September 2017
FL724A-Q
NHTSA #16V-666 (Non-School Buses)
NHTSA #16V-664 (School Buses)
THIRD REVISED NOTICE

Subject: ICU3S Instrument Cluster Hydraulic Brake Telltale

Models Affected: Specific Freightliner Business Class M2 vehicles and Freightliner Custom Chassis S2 bus and B2 (Thomas Built Buses C2 Saf-T-Liner) school bus chassis manufactured March 3, 2015, through September 8, 2016.

Fig. 1, A "Park" Telltale - Replace ICU3S

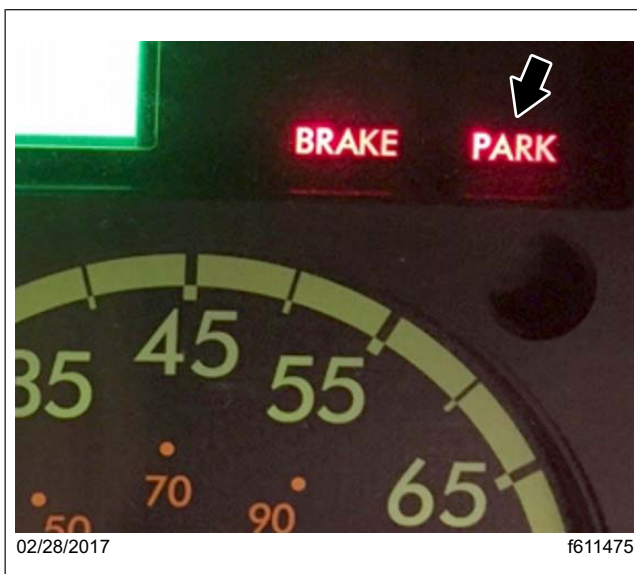
1. Check the base label (Form WAR259) for a completion sticker for FL724 (Form WAR260) indicating this work has been completed. The base label is usually located on the passenger-side door, about 12 inches (30 cm) below the door latch (trucks) or over the driver's window (buses). If a completion sticker is present, no work is needed. If a completion sticker is not present, proceed to the next step.
2. Park the vehicle, shut down the engine, and apply the parking brakes. Chock tires.
3. During the bulb check at key-on, inspect the telltales on the ICU3S (affected telltales will be illuminated for three seconds). See [Fig. 1](#) and [Fig. 2](#).

If the ICU3S has a "Park" telltale, continue with the next step.

The instrument clusters will be inspected and replaced with clusters displaying the correct warning as needed.

Fig. 2, A "Brake" Telltale is OK - No Replacement

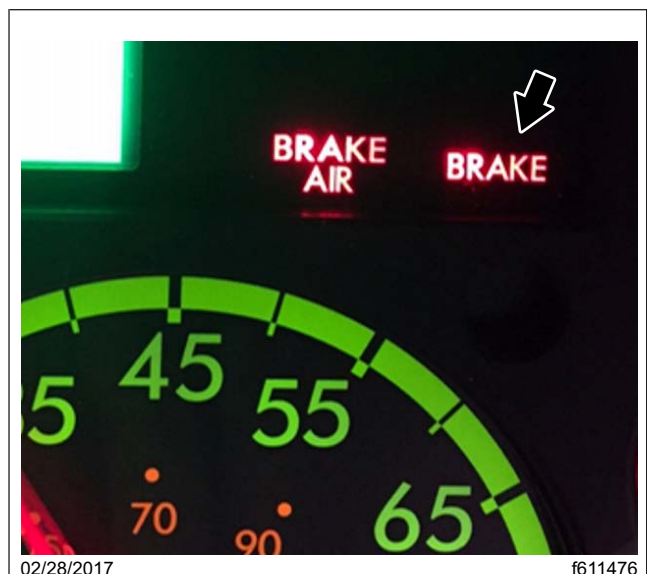
If the ICU3S has a "Brake" telltale, no further work is needed. Clean a spot on the base label (Form WAR259), write the recall number, FL724, on a red completion sticker (Form WAR260), and attach it to the base label.
